Bidder acknowledges receipt of and has added to and made a part of the proposal and contract documents the following addendum (addenda):

- 1 Revised Table of Contents; Revised NTB Nos. 937, & 938; Added NTB Nos. 986, 987, 1029, & 1030; Revised Wage Rates; Revised Bid Items; Revised or Added Plan Sheet Nos. 2, 7-10, 12-24; Amendment EBS Download Required.

PROJECT: NH-0055-02(248)/102315302 - Madison

SECTION 904 - NOTICE TO BIDDERS NO. 937

Typical Sections: The following typical sections are applicable to the above mentioned sites.

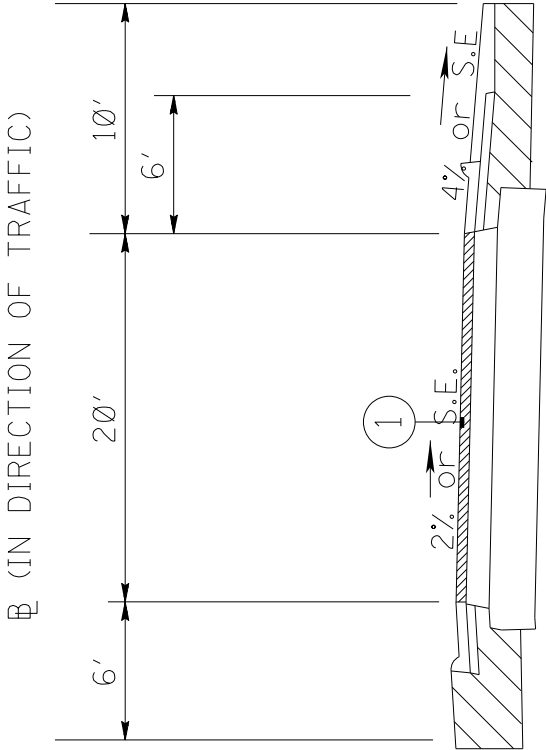
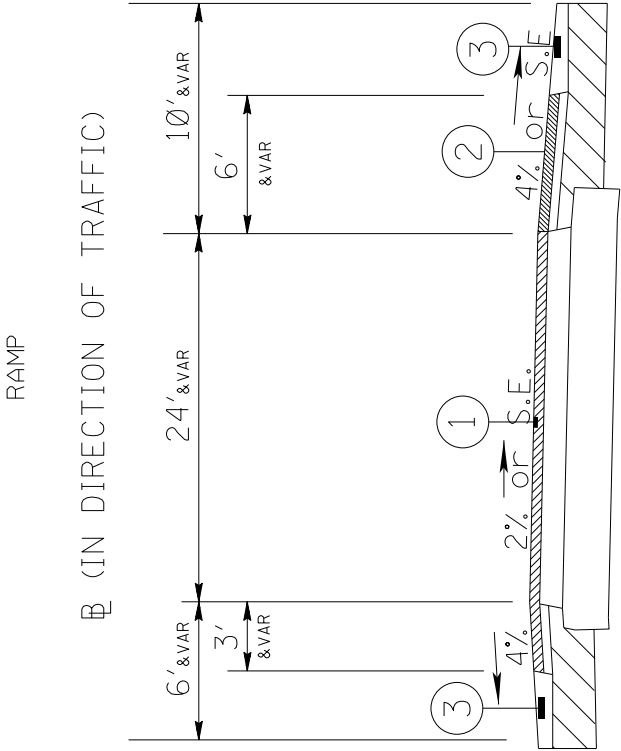
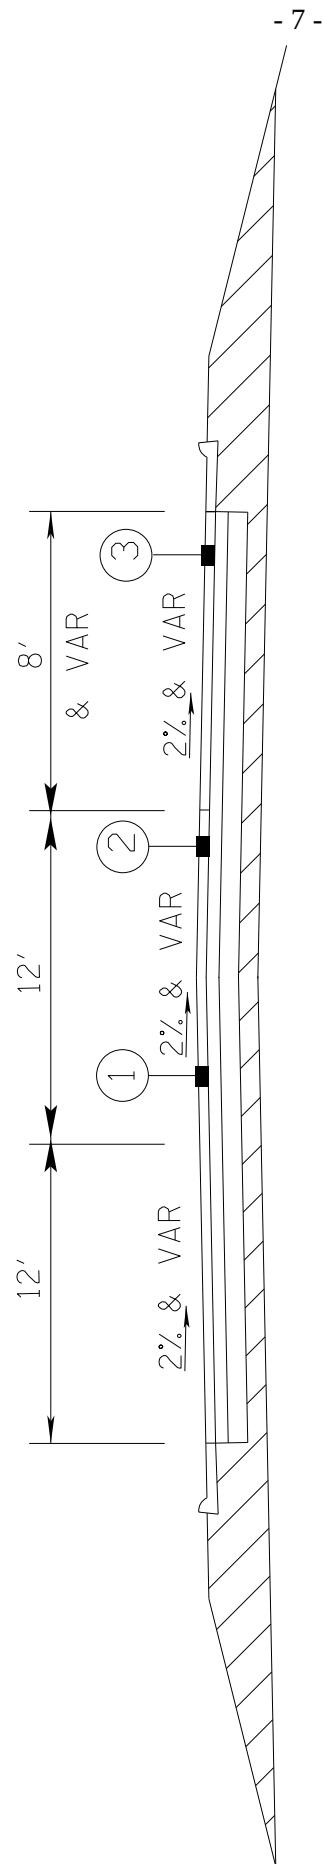
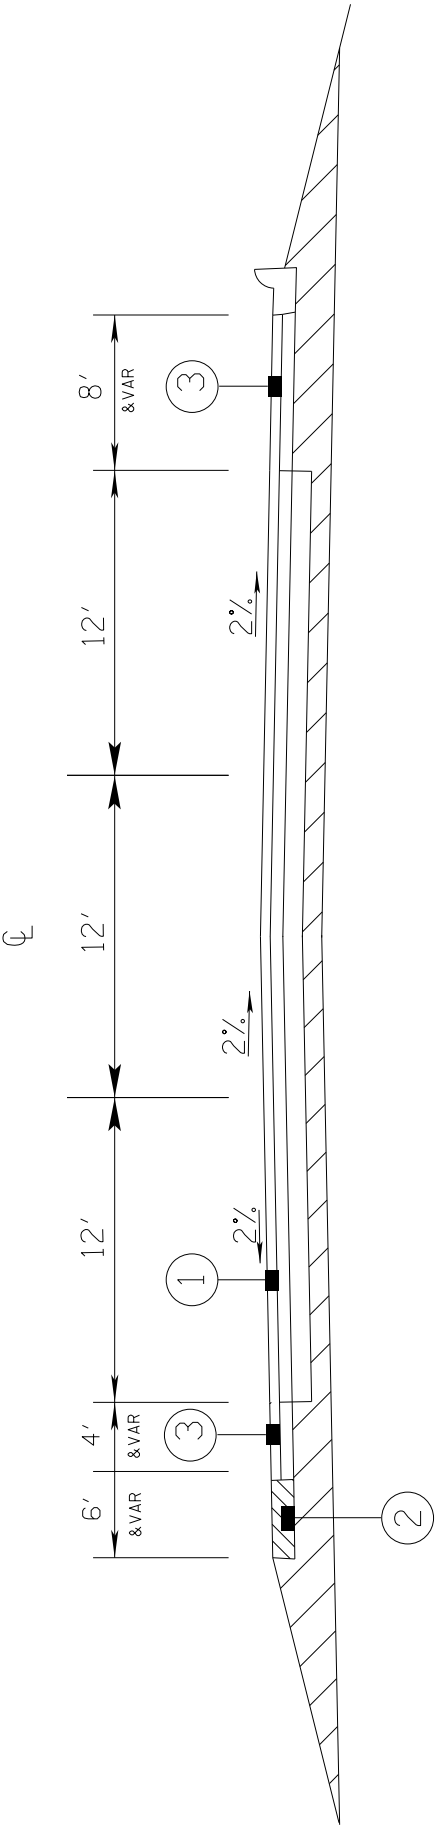
Work in this area shall consist of milling 2" and overlaying the travel lanes, roundabout, and local roads with 2" of 12.5-mm, HT, Asphalt Pavement, Polymer Modified per the attached typical sections. The paved shoulders will be milled 2" and replaced with 2" of 12.5-mm, ST, Asphalt Pavement.

- ① 2" FINE MILLING AND REPLACE WITH 2" ASPHALT PAVEMENT, HT (12.5 mm MIXTURE) POLYMER MODIFIED (102" LIFT)
- ② PRE-LEVEL WITH 12.5MM, HT, ASPHALT PAVEMENT LEVELING

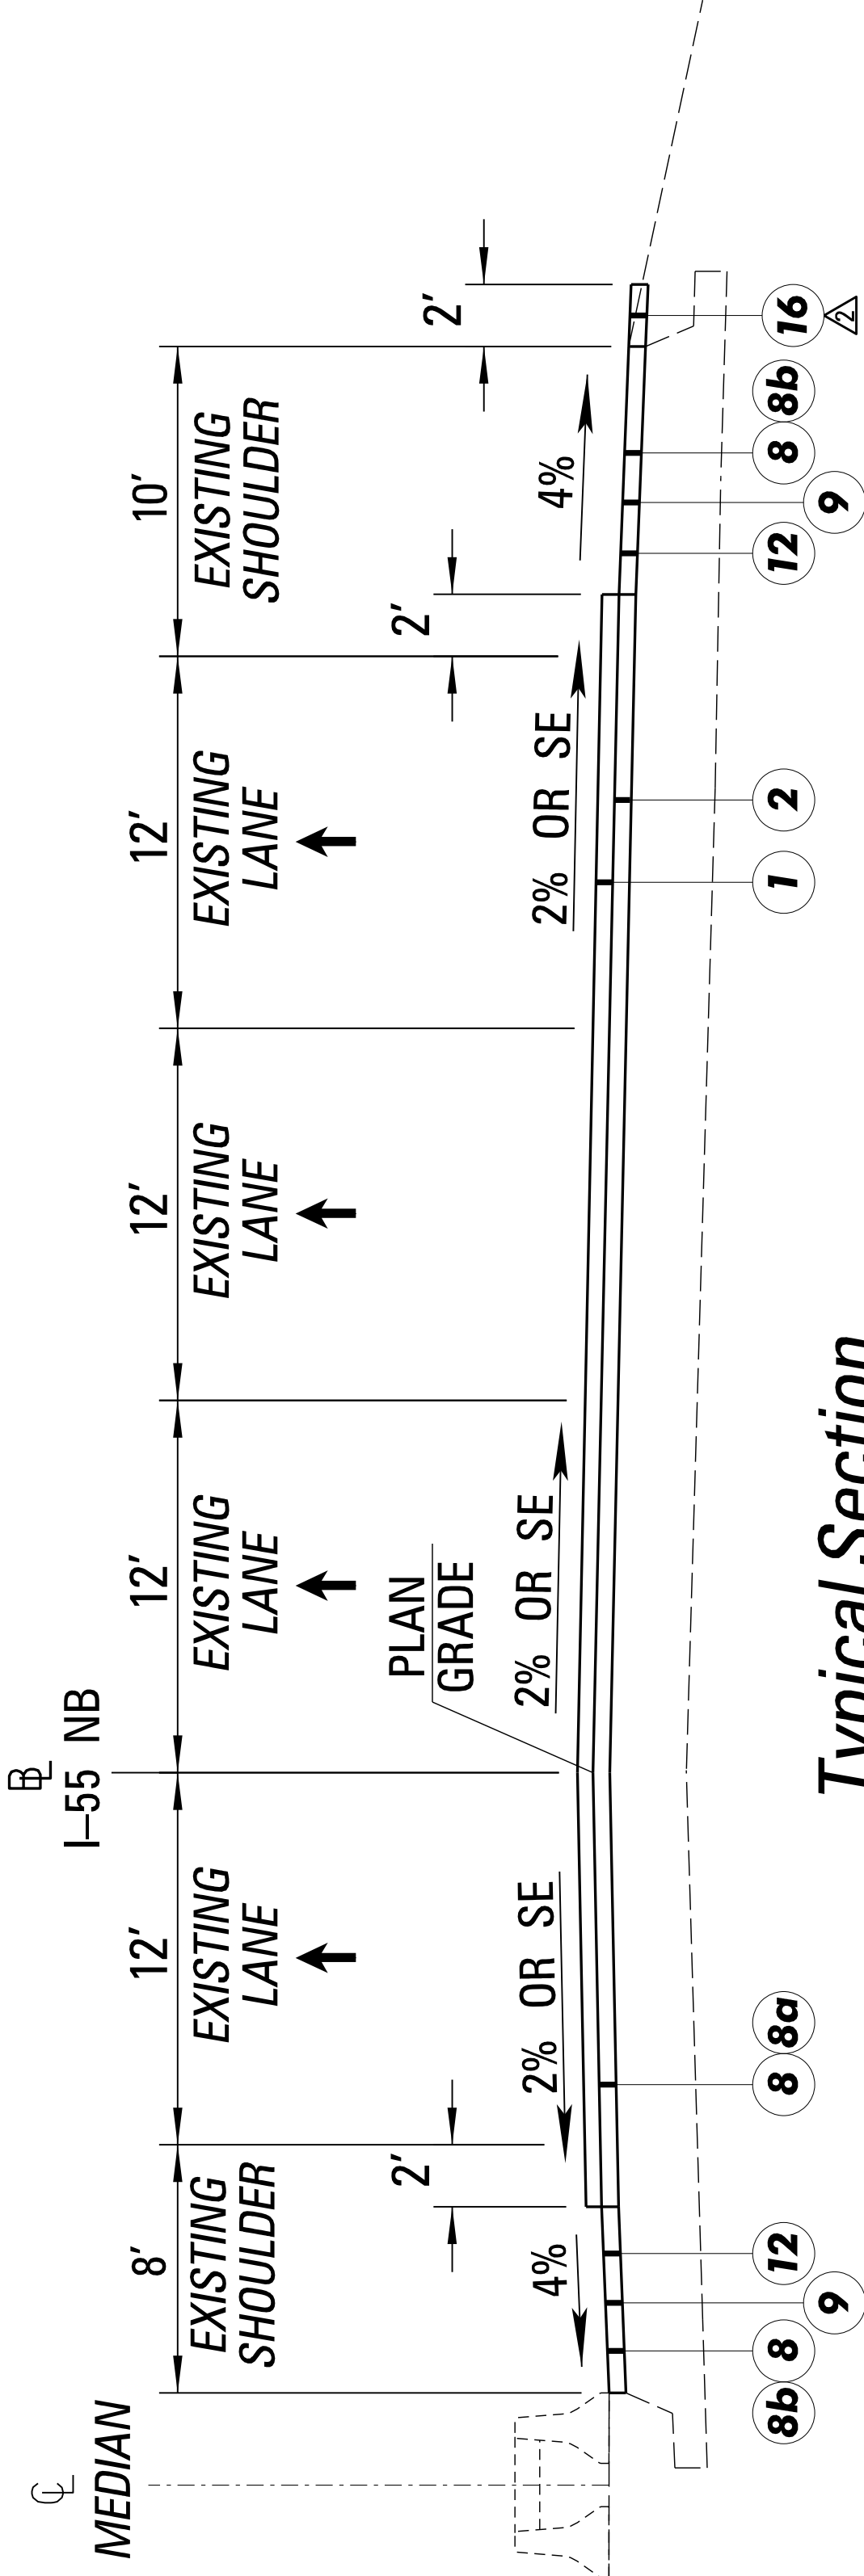
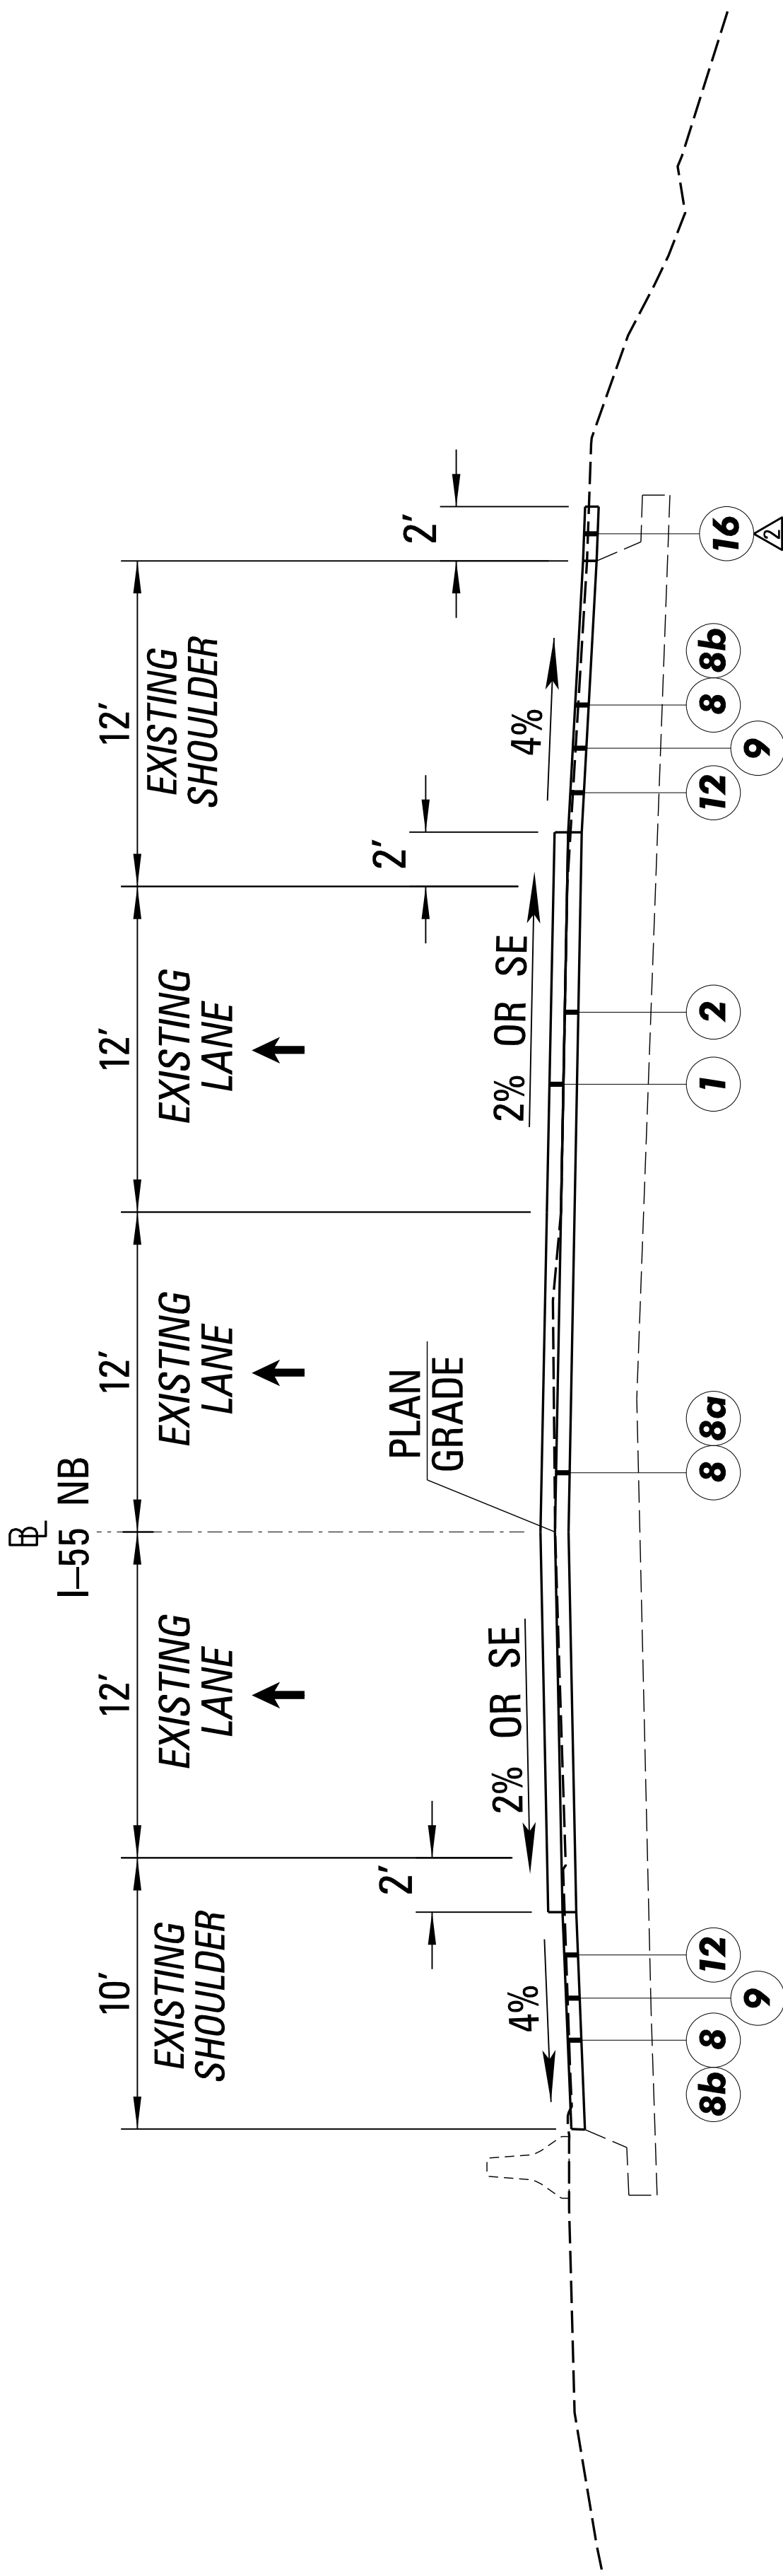
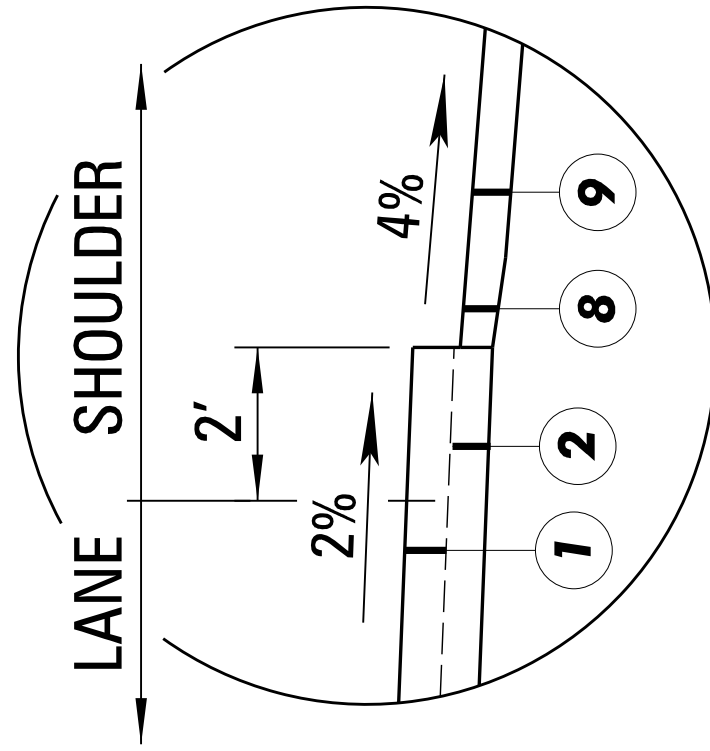
SAFETY EDGE REQ'D
TOP 2 LIFTS ONLY
(NOT A PAY ITEM)
OVERLAY
